# 1963 - 1967 Corvette: Service News: Corvette Coupe Body Rework for Larger Racing Tires (Rear Wheels)

**Subject:** Corvette Coupe Body Rework for Larger Racing Tires (Rear Wheels)

**Model and Year:** 1963 - 1964 Corvette

**Date:** August 1964, Volume 36, Issue Number 7

Fig. 2—Rework of 1963-64 Corvette Model 837 for Installation of Larger Tires

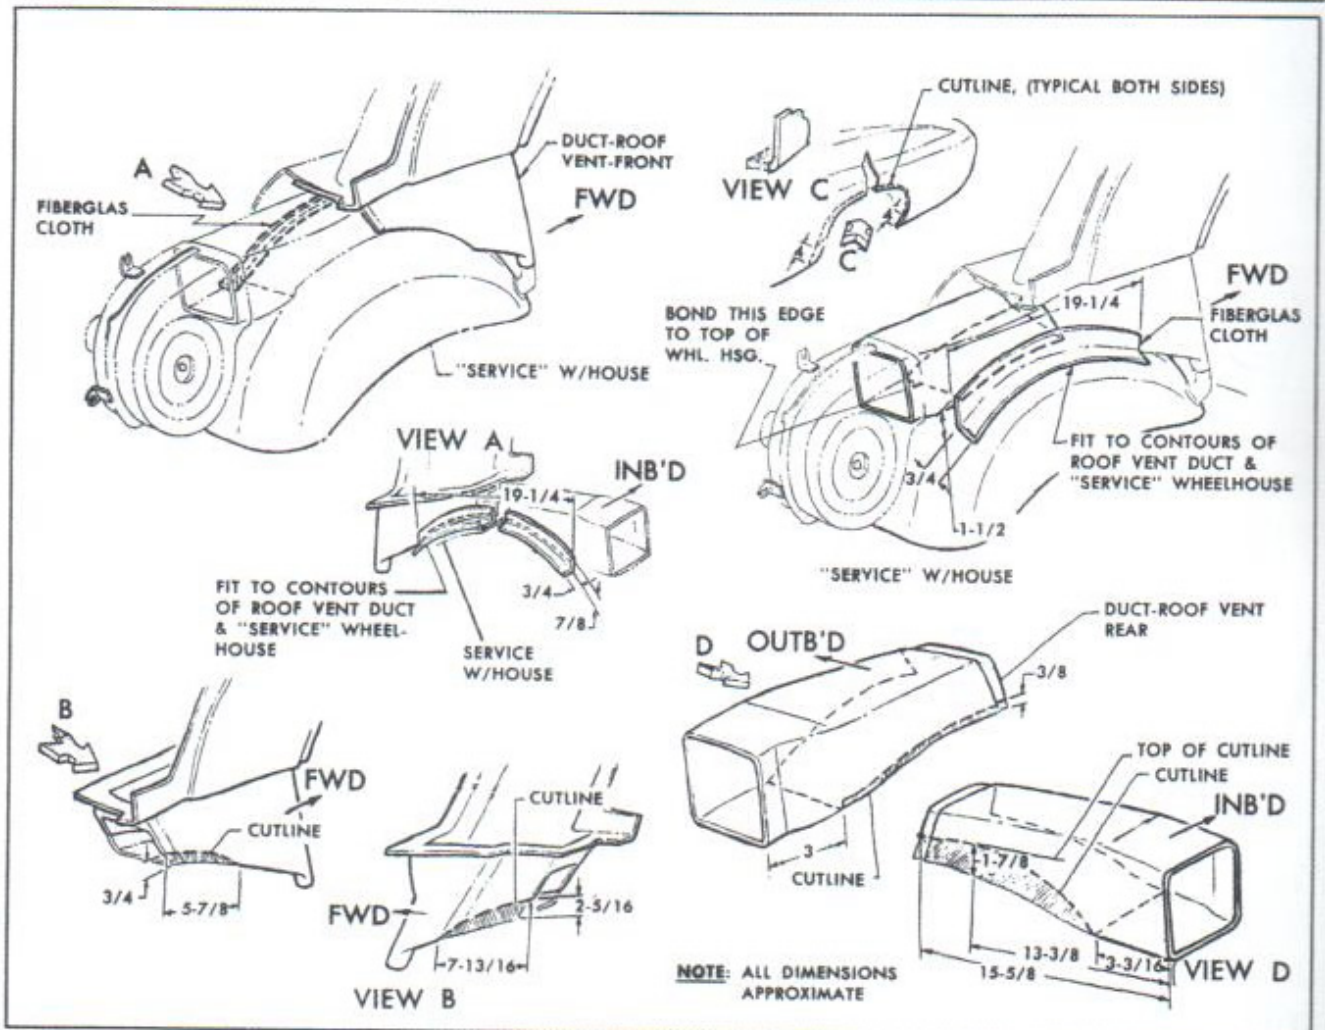
On closed models, adequate wheel travel clearances may be obtained for 7.10-7.60 x 15 tires mounted on RPO P48 Aluminum Knock-off Wheels (6" rim width) by installing the inner wheel housings which are used in Production with the RPO N03 fuel tank of 35 gallon capacity, and by cutting material away in the wheel openings. These wheel housings are serviced under P/N's 3794441 and 3794442 for the right and left sides respectively. On the left side, considerable rework is required to make the larger wheel housings fit under the body rear compartment air exhaust duct. Individual owners may elect to have the exhaust duct system removed instead of going to the expense of the rework. If the rework is undertaken, the efficiency of the rear compartment air exhaust system will be decreased because of the reduced duct area just over the wheel housing.

Refer to Figure 2 for details of the installation of the larger wheel housings, the provision of extra clearance between the tire and wheel openings, and the

modification of the body rear compartment air exhaust duct. In those areas where cutting and rebonding of fiberglass is involved, regular shop practices and materials should be used. The use of the materials show in Group 12,800 of the Chevrolet Parts Catalog is suggested.
